No. EL/3.2.119/3-phase (TBU)

SPECIAL MAINTENANCE INSTRUCTION No. RDSO/2007/EL/SMI/ 0251, Rev. '2'

- 1.0 **Title:** Maintenance instructions for Brake Hangers for WAG9/WAG9H Electric Locomotives fitted with TBU/PBU brake rigging arrangement.
- 2.0 **Background:**

FIG 1: SLING ARRANGEMENT

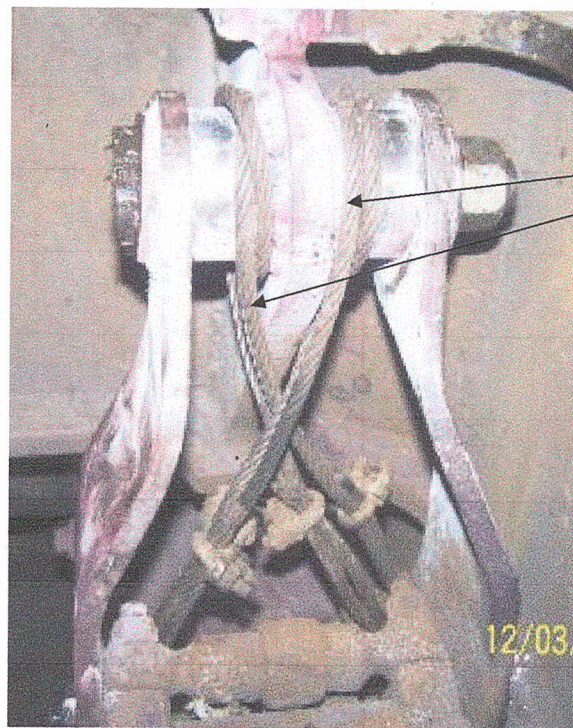
- 3.2 Sheds to provide double safety sling in cross-wise arrangement as per CLW's drawing no. 1209-01.416-063 to prevent falling of brake unit on line. Modified safety slings should be of 8mm dia., 1100 mm long as per IS 2762:1982, 6x7 construction with steel core, double crimped at both ends and fastened with 16x70 mm hex. head screw (property class 8.8) with nyloc nut and washers on both levers in the existing hole. This has to be ensured by the shed to prevent falling of Brake hanger assembly on line.

Double safety sling of length 1100 mm (cross wise fitment)

FIG 2: BRAKE EQUIPMENT WITH CURVED SLIT

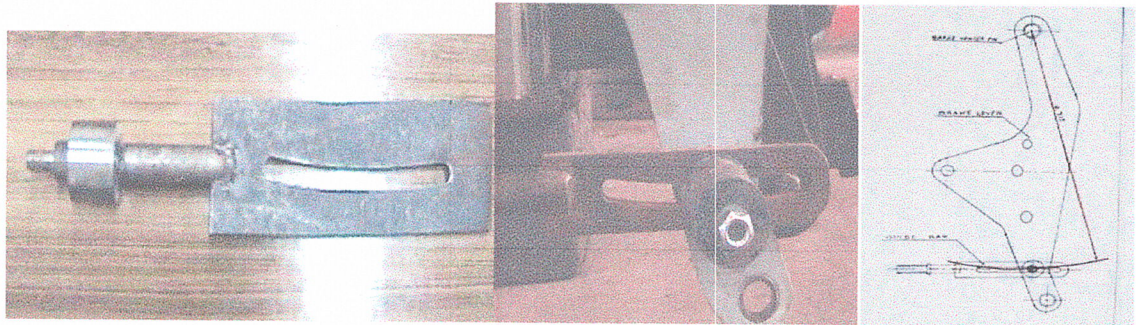
- 3.5 Ensure that the slit in the brake equipment should be in arc of 717 mm radius as given below in fig 2.

FIG 3: CHECKING FOR PARALLELISM WITHOUT REMOVING BRAKE HANGERS FROM BOGIE

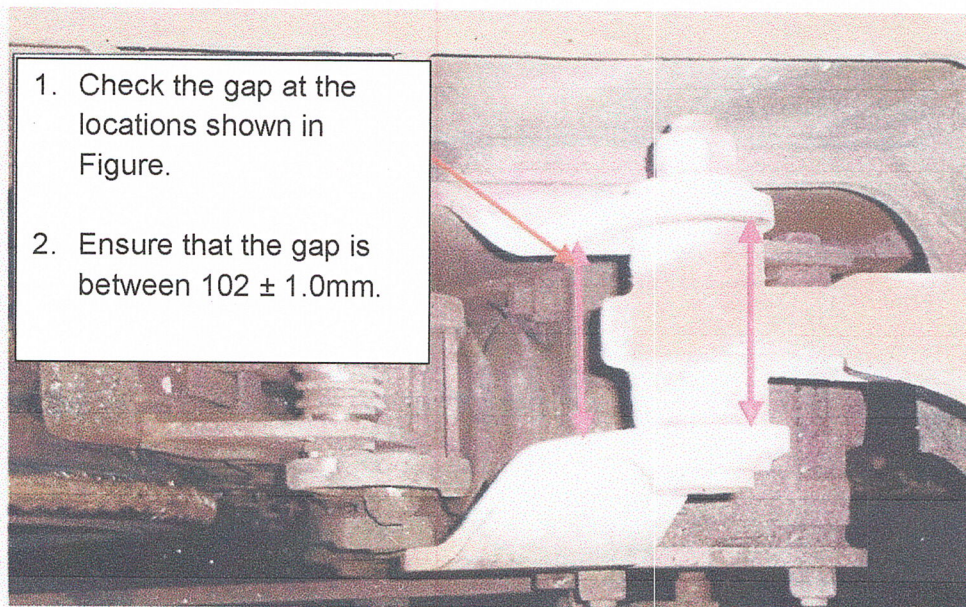
- 3.6 Ensure availability of slack adjuster on all units. No loco should be allowed to work without slack adjusters.
- 3.7 Parallelism of Brake Hangers should be checked using go/no-go Gauge as shown in Fig. 3. This should be done once as a special drive and subsequently during IC.
